**METROPOLITAN GOVERNMENT OF NASHVILLE AND DAVIDSON COUNTY**

**STAFF RECOMMENDATION**  
**1820 Fourth Avenue North**  
**September 21, 2016**

**Application:** New construction—outbuilding; Setback determination  
**District:** Salemtown Neighborhood Conservation Zoning Overlay  
**Council District:** 19  
**Map and Parcel Number:** 08108030300  
**Applicant:** Ernest McClain, Owner  
**Project Lead:** Sean Alexander, sean.alexander@nashville.gov

**Description of Project:** Application is to construct an outbuilding at the rear of the lot. The building will be a single story carport, open on three sides with a pair of garage doors facing the alley. The structure requires a rear setback determination from twenty feet (20') to ten feet (10').

CARPORT PLAN & ELEVATION		
Project number	Project Number	<b>H7.1</b>
Date	9/12/16	
Drawn by	Yohana A.	
Checked by	Checker	
		Scale As indicated

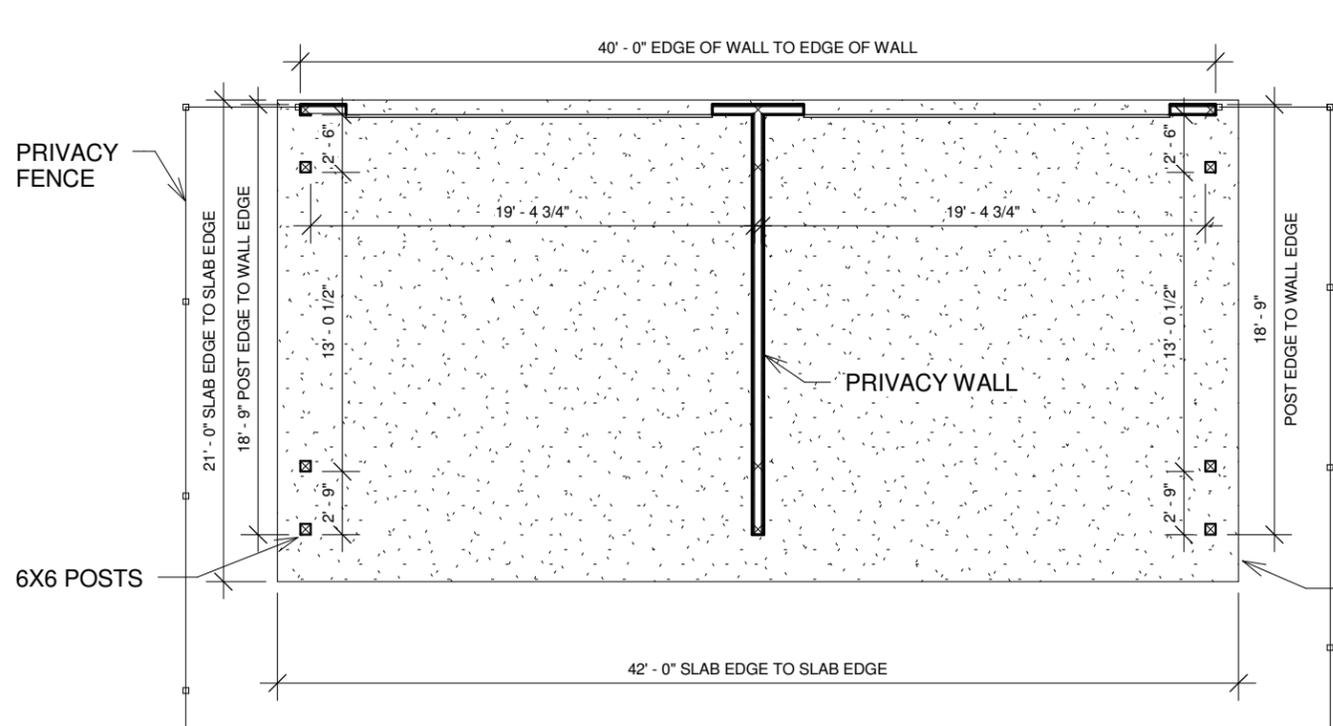
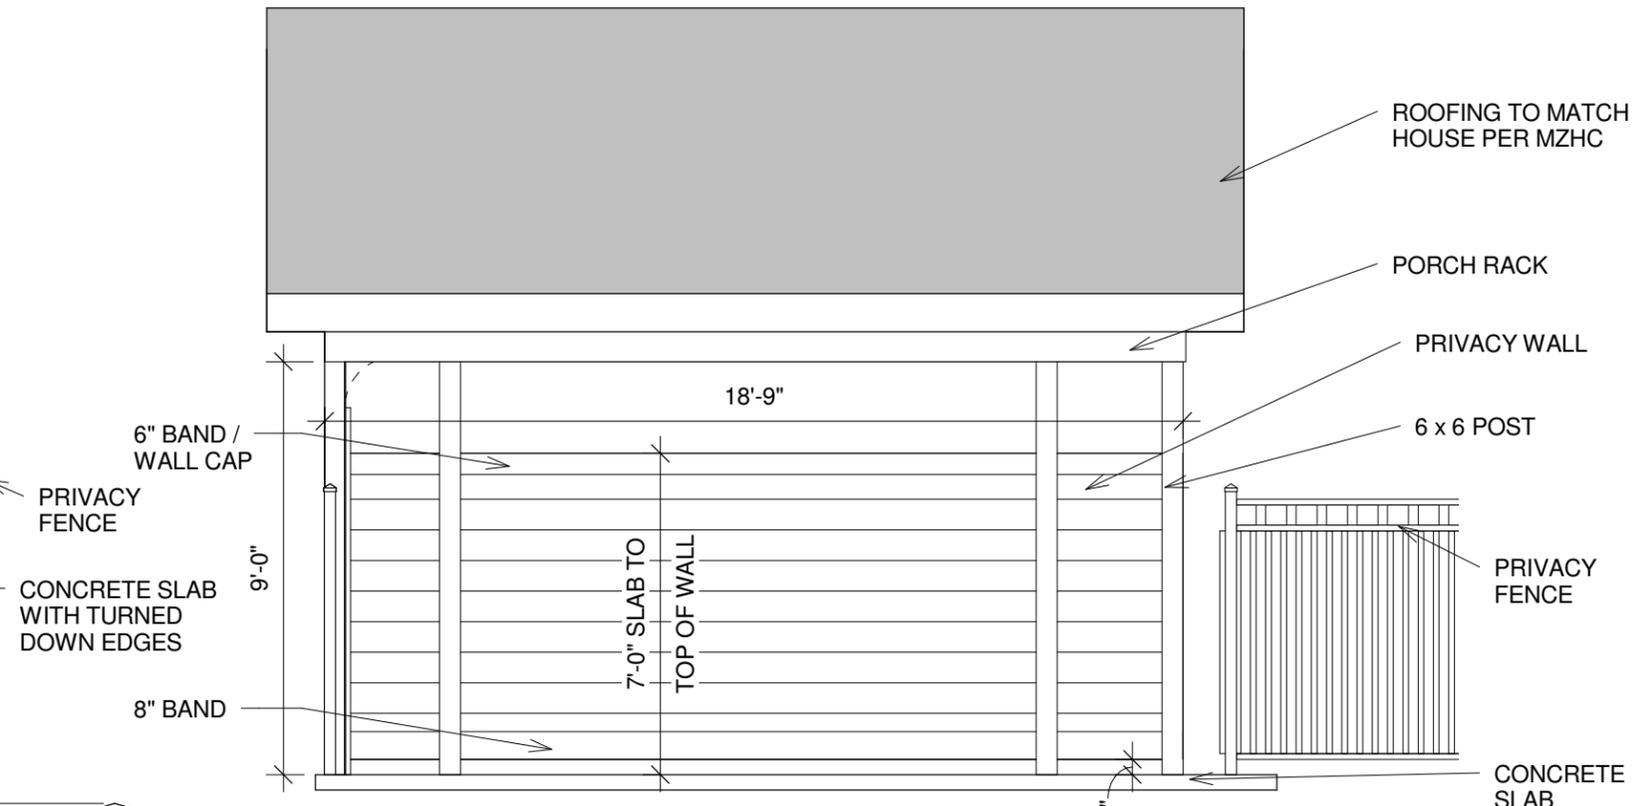
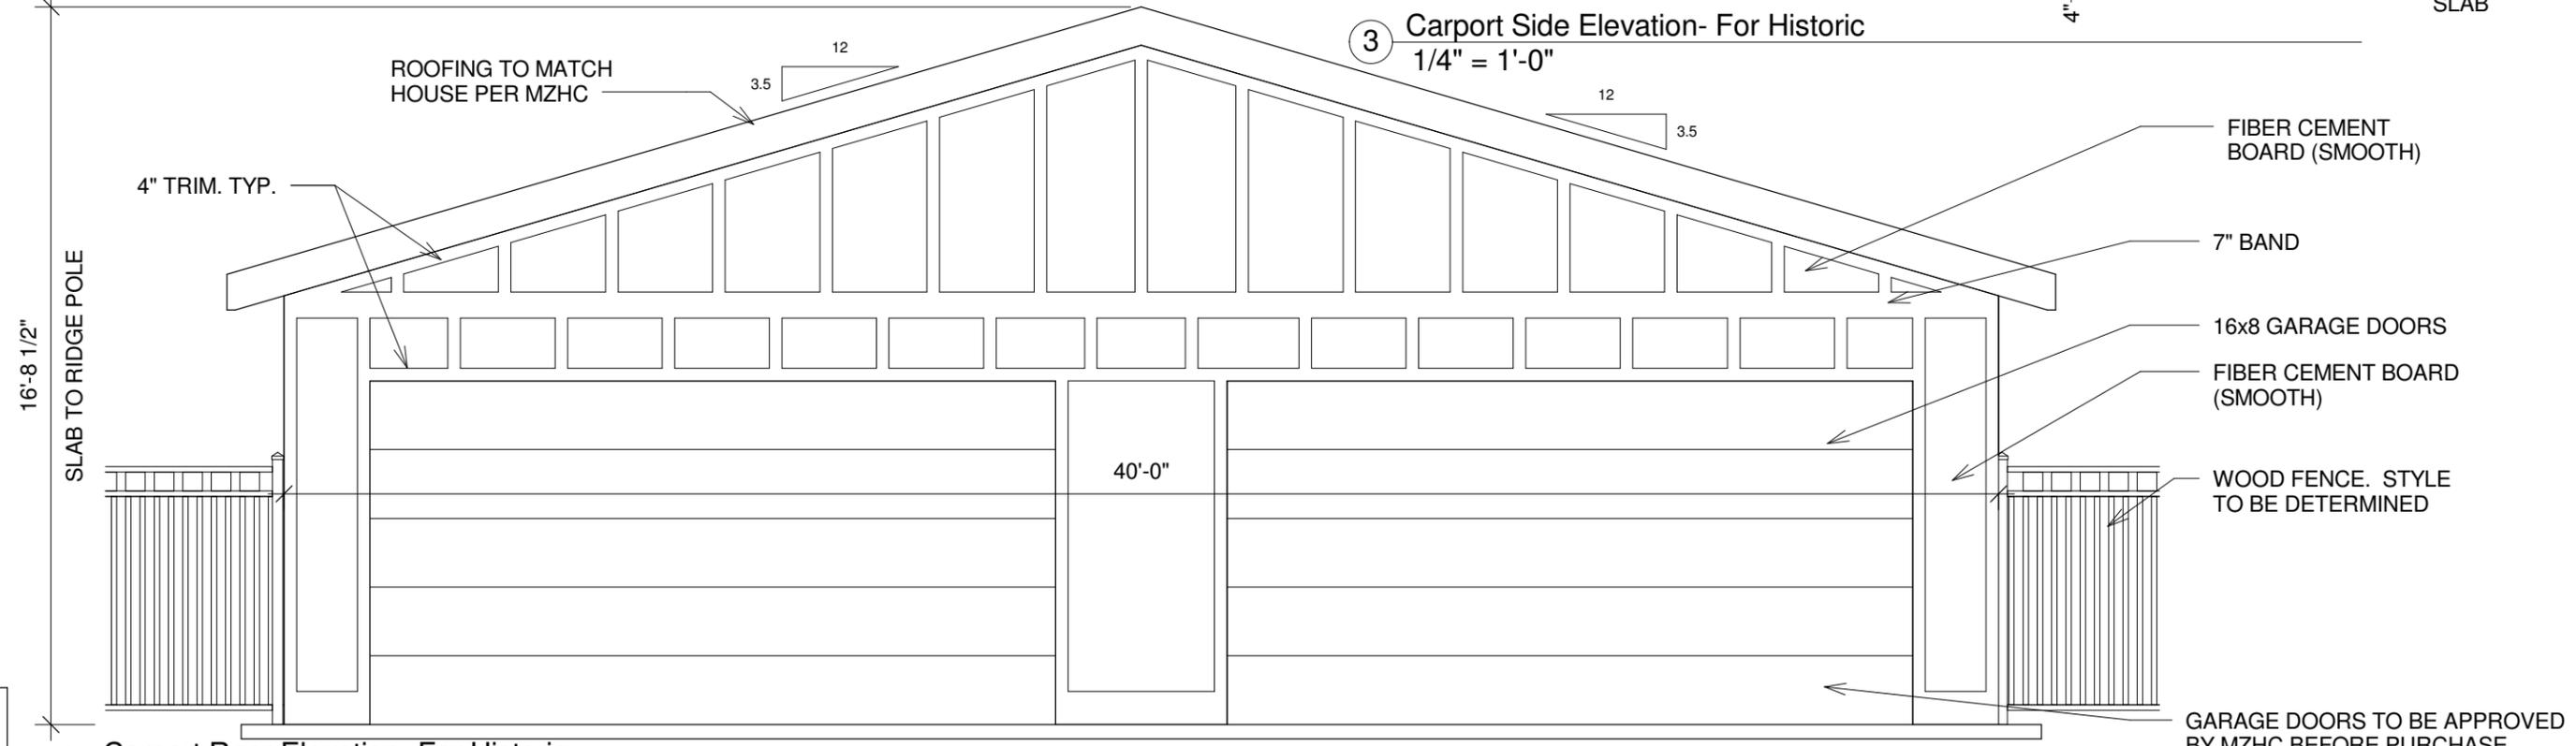
Proposed Element	Proposed Form	Typical of district?
Primary form	Gable	X
Primary roof slope	3.5:12	X

Staff finds the form and slope to be similar to historic outbuildings, and that the project meets Section II.H.1 and 3 of the design guidelines.

The accessory structure will be open on three sides with a pair of garage door facing the alley to the rear. It will have a simple, utilitarian design that is appropriate for outbuildings and the roof form and detailing will complement the primary structure. Additionally, it will be located behind the building and therefore obscured from view from the front.

<b>Proposed</b>	<b>Color/Texture</b>	<b>Approved Previously or Typical of Neighborhood</b>	<b>Additional Review Required</b>
<b>Foundation</b>	Concrete slab	Natural color	X	
<b>Cladding</b>	Cement-fiber panels and battens	Smooth with 5” reveal	X	
<b>Trim</b>	Cement fiber	smooth	X	
<b>Roofing</b>	Asphalt shingle	Match primary building	X	
<b>Driveway</b>	Concrete apron	Natural color	X	
<b>Vehicle Doors</b>	Not indicated	Needs final approval		X

With the staff’s final approval of the garage doors, staff finds that the known materials meet Section II.H.4 and 5 of the design guidelines.

**Recommendation Summary:** Staff recommends approval of the outbuilding and setback determination with the condition that the garage doors are approved by MHZC Staff prior to purchase and installation.
